HISTORIC PRESERVATION COMMISSION

STAFF REPORT Department of Growth Management

MEETING DATE:	July 6, 2016
PROJECT:	Lot 17B, 5778 Yaupon Road – New Construction: Single-Family Residential
APPLICANT:	Southern Coastal Homes
PROJECT MANAGER:	Erin Schumacher, AICP, Senior Planner

PLAN REVIEW COMMENTS FOR COFA-05-16-009675

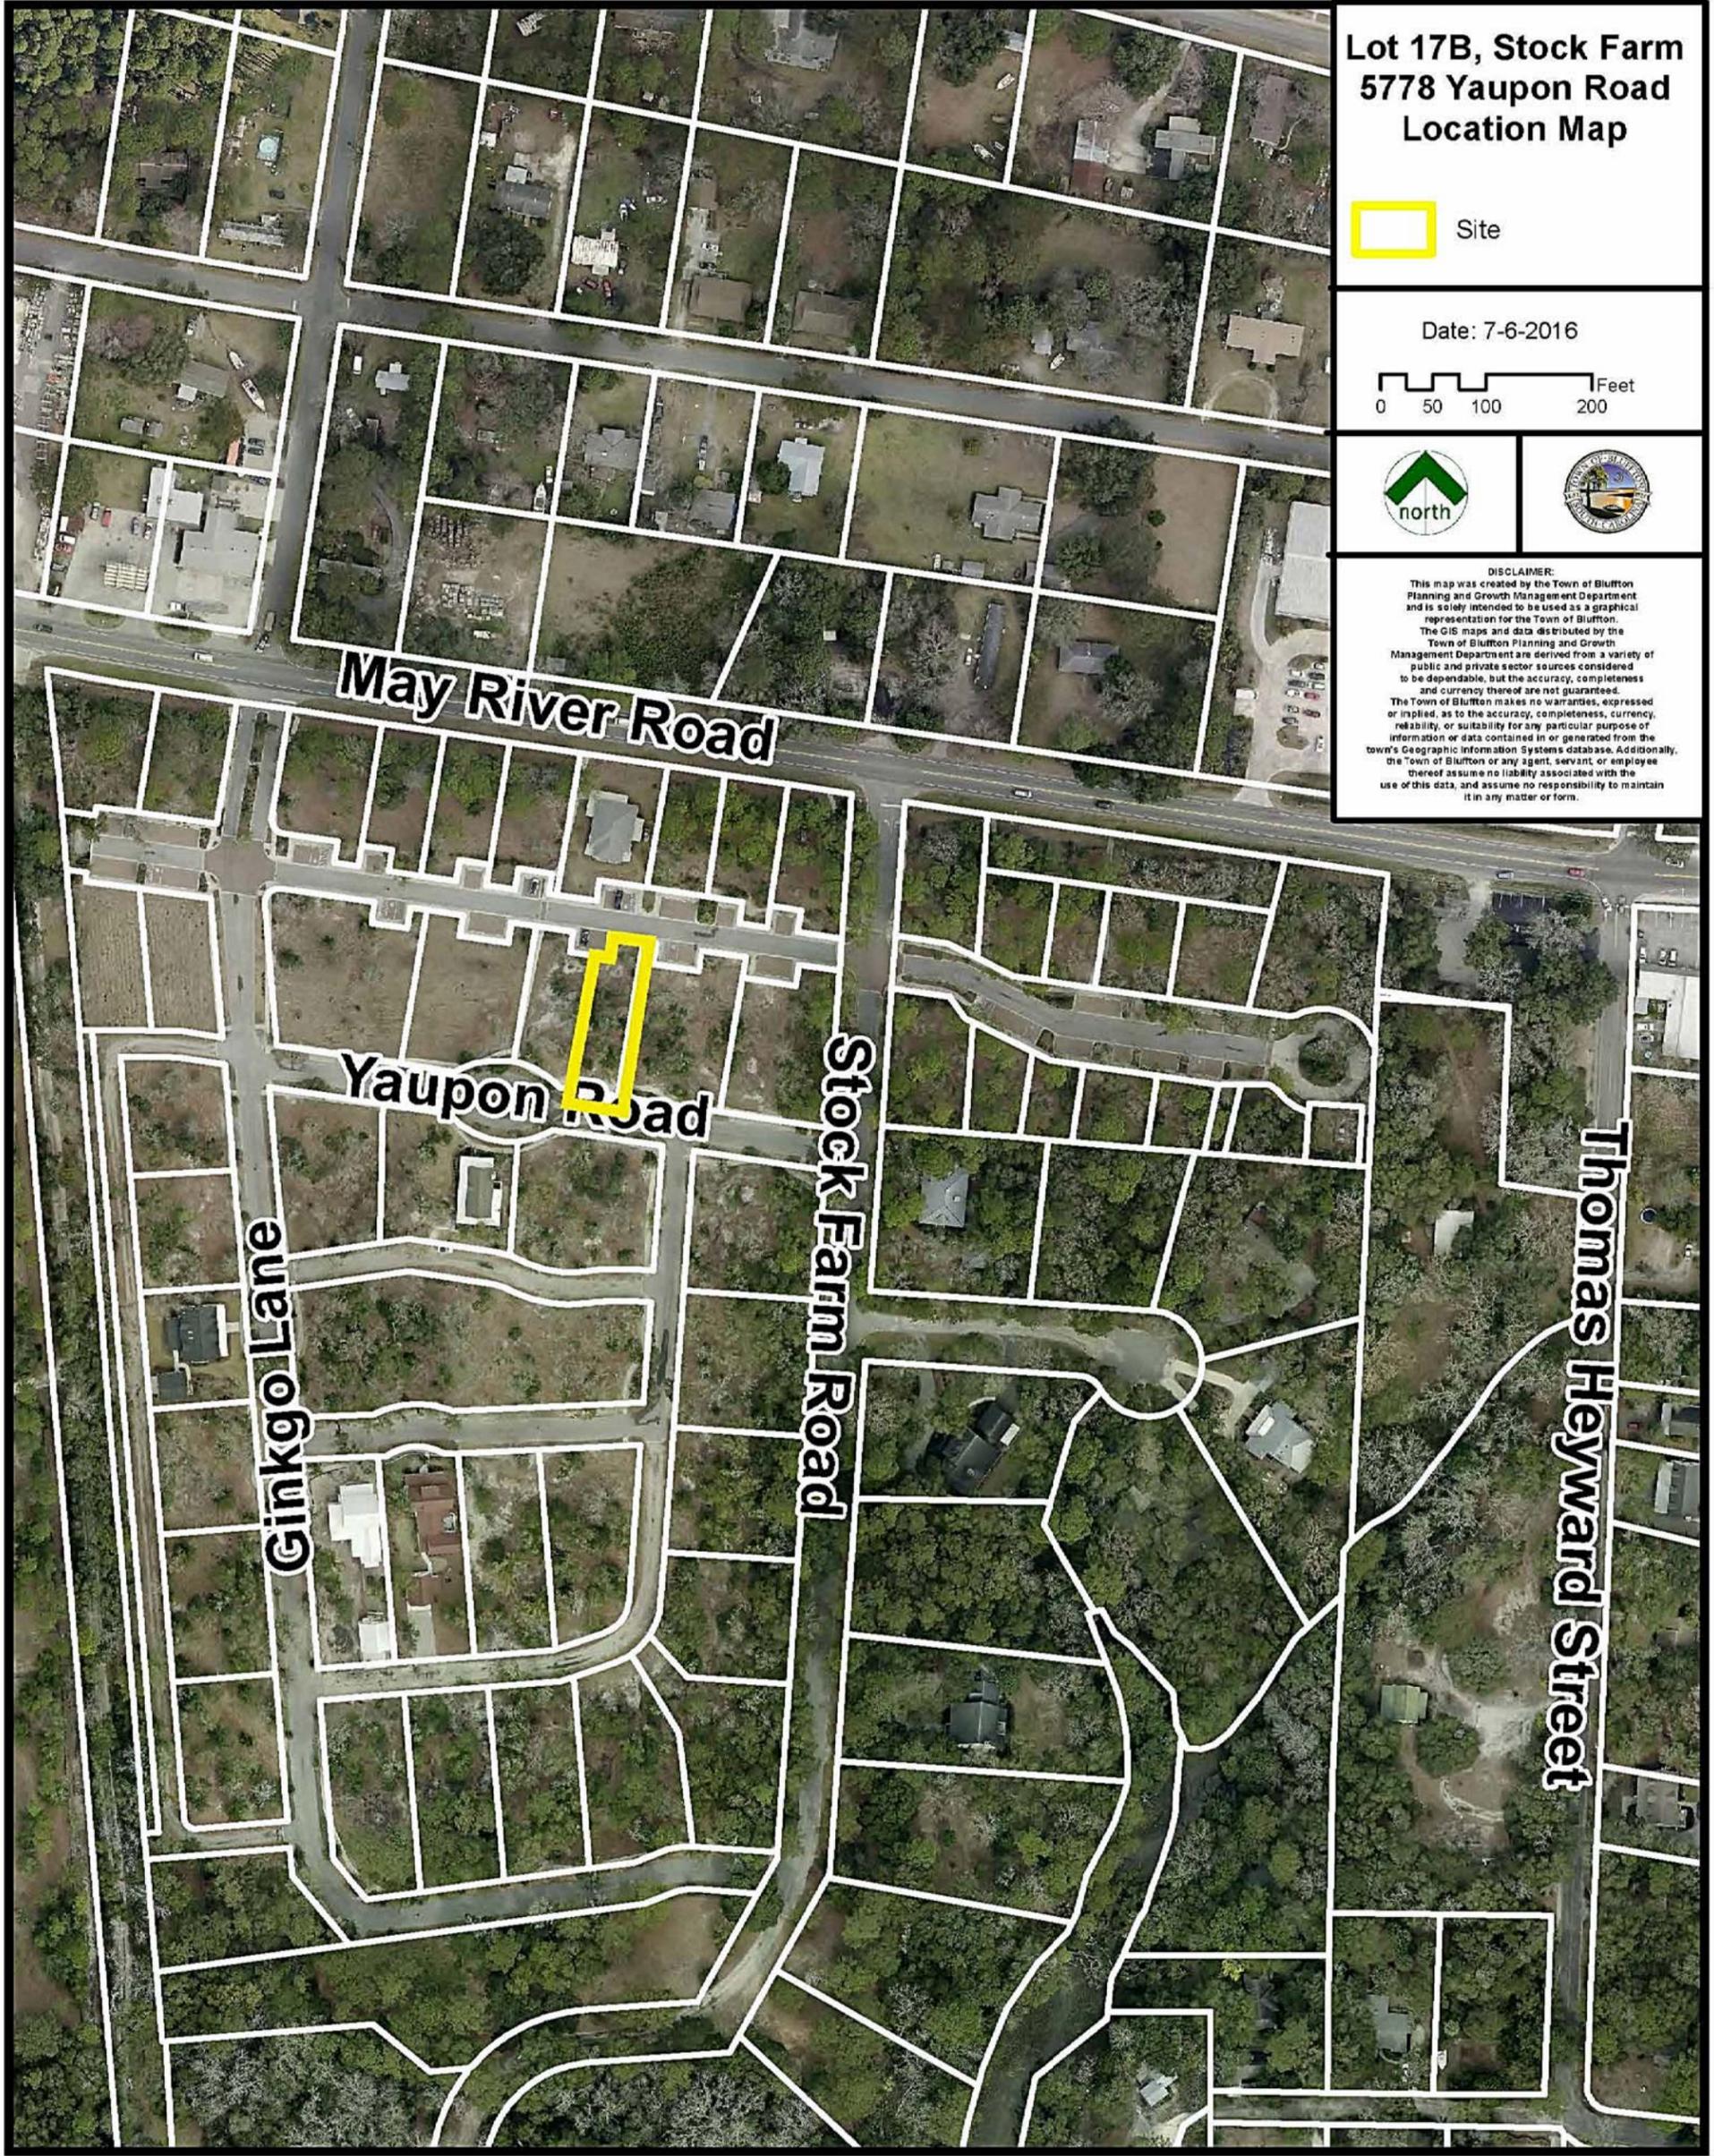
- 1) Section 5.7.4.A.5. - Lot Layout and Design. As shown on the site plan access to the lot is currently proposed through existing street parking. The UDO states that every lot shall have access to a public or private roadway and that the access may be recorded via a cross or shared access easement. Additional information about the access to this lot must be provided.

1. Per the Applications Manual, a letter of approval from the Stock Farm HARC must be submitted, and any conditions addressed, before the issuance of the Certificate of Appropriateness.
2. Per Section 5.7.4.A.5., access must be provided to a public or private roadway through a curb cut and recorded (if necessary) via a cross or shared access easement.

SOUTHERN COASTAL HOMES
LOT 17B
STOCK FARM | BLUFFTON, SOUTH CAROLINA
FRONT AND REAR ELEVATIONS

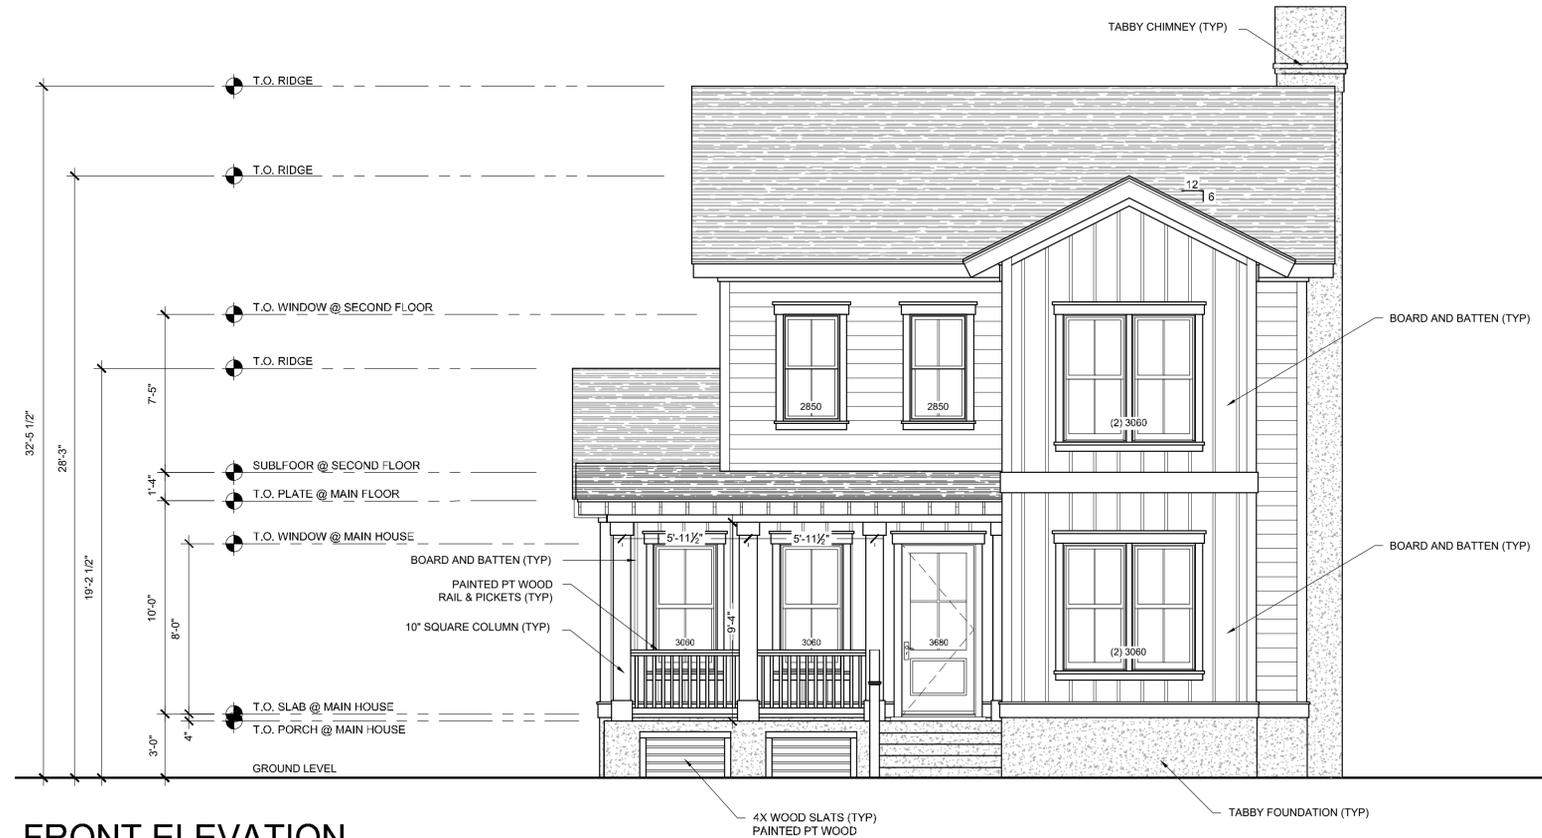
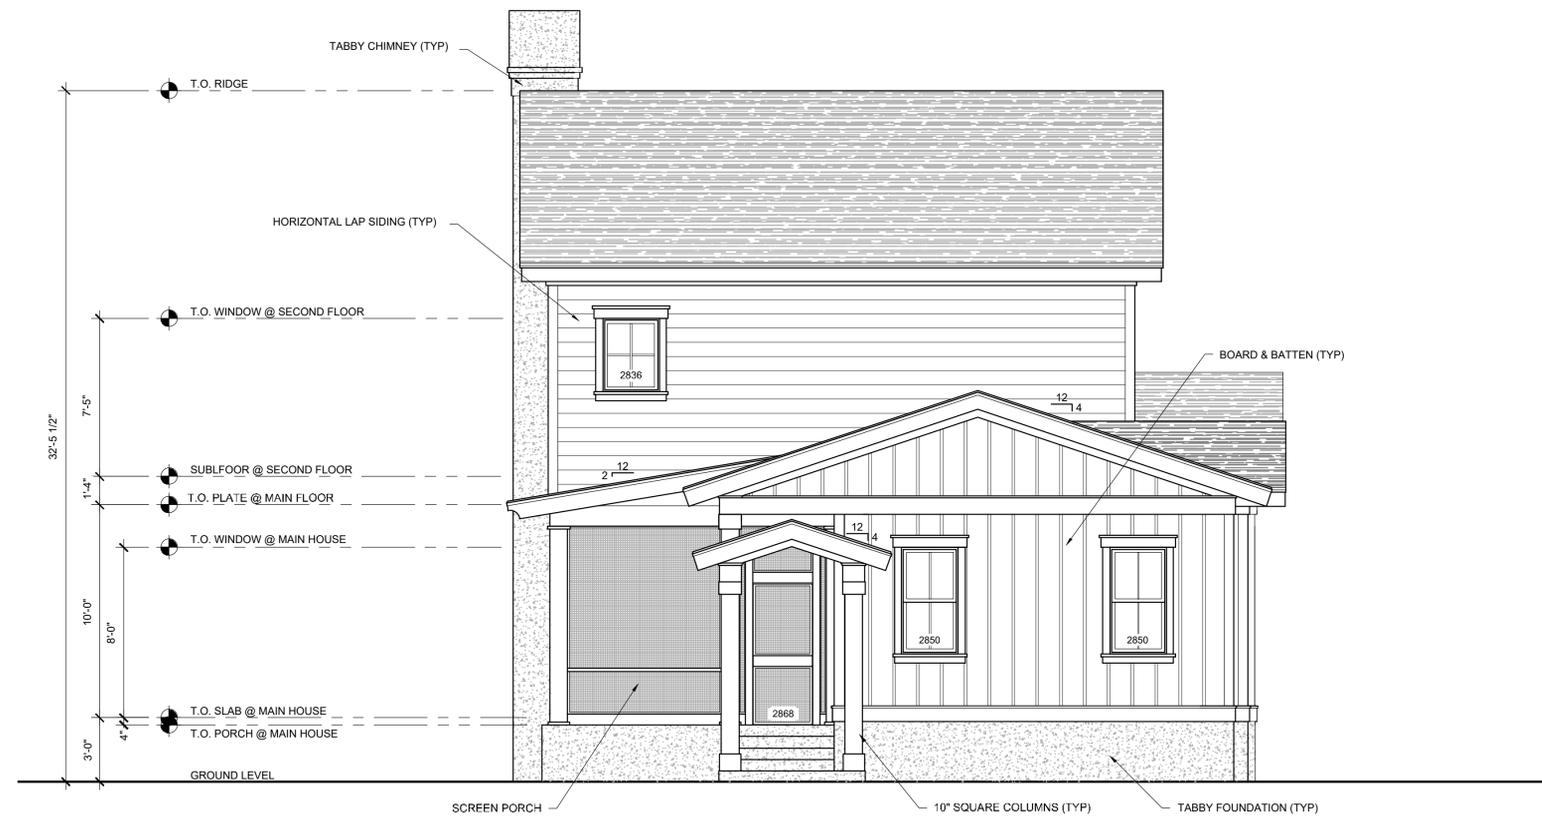
- There appears to be a discrepancy between the floor plan used on the site plan and that shown in the architectural set and that there may be an issue with the plan fitting within the required setbacks. The site plan must be updated to show the correct floor plan. (Applications Manual)
- For the final submission, provide material call outs on the elevations for clarity. (Applications Manual)
